DEVELOPMENT ASSESSMENT REPORT

Application No.	D/2019/371
Address	3 Hosking Street BALMAIN EAST NSW 2041
Proposal	Alterations and additions including 3 storey side extension, lift, ground works and tree removal
Date of Lodgement	19 September 2019
Applicant	Apwdesign
Owner	Mr Justin D Boyd Mrs Ronite A Hammond
Number of Submissions	Initial: 0 Amended: 0
Value of works	\$349,514.00
Reason for determination at Planning Panel	Clause 4.6 variation exceeds 10%
Main Issues	Overdevelopment of Site
Recommendation	Refusal
Attachment A	Draft Conditions
Attachment B	Plans of proposed development
Attachment C	Clause 4.6 Exception to Development Standard – Floor Space Ratio
Attachment D	Statement of Significance - Balmain East Conservation Area

Revised clause 4.6 written request | Floor space ratio | 3 Hosking Street, Balmain East

Existing side yard Landscaped Area viewed from rear of site

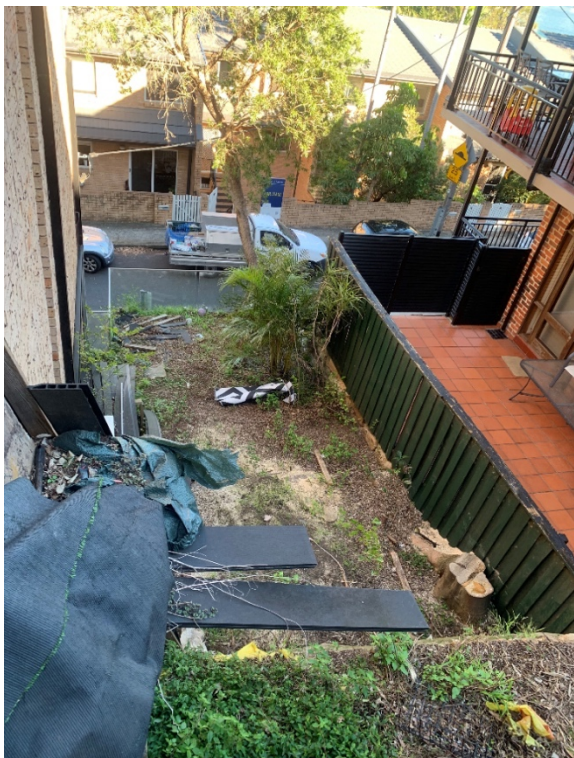
- The bulk of the proposed additions results in the existing Landscaped Area on the site being reduced to an unsuitable area of rock shelf and setback between the building and rockface at the rear of the site. Further, the area of landscaped yard shown on plans in front of the additions is located on an existing concrete slab and is therefore not Landscaped area as defined.

Figure 1: Existing dwelling on the subject site, marked up to indicate the other dwelling in the pair. The view is from Hosking Street.

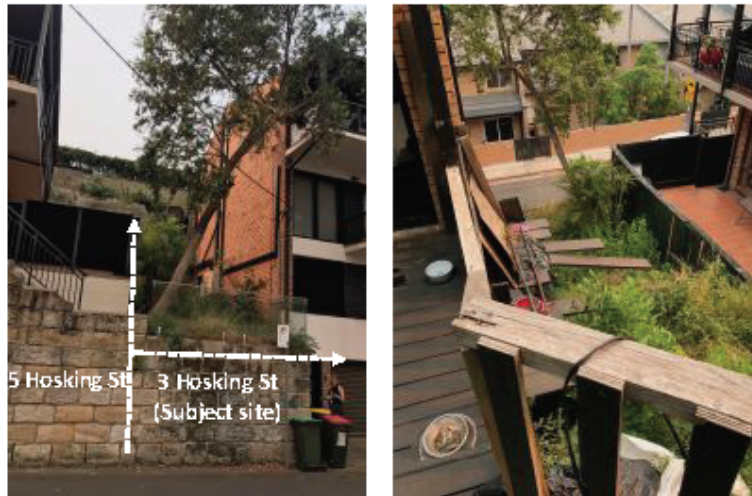
In relation to the better urban planning outcome that would be created, Figure 1 below shows the existing building on the subject site, and Figure 2 below shows the undeveloped area of the site. Figure 3 show that same undeveloped area from a raised position at the back of the site. That undeveloped area is formed by a 2.2 metre high sandstone retaining wall across the street boundary, with a glazed balustrade on top of it. There is a tree approximately 1.0 metre back from the inner edge of that retaining wall.
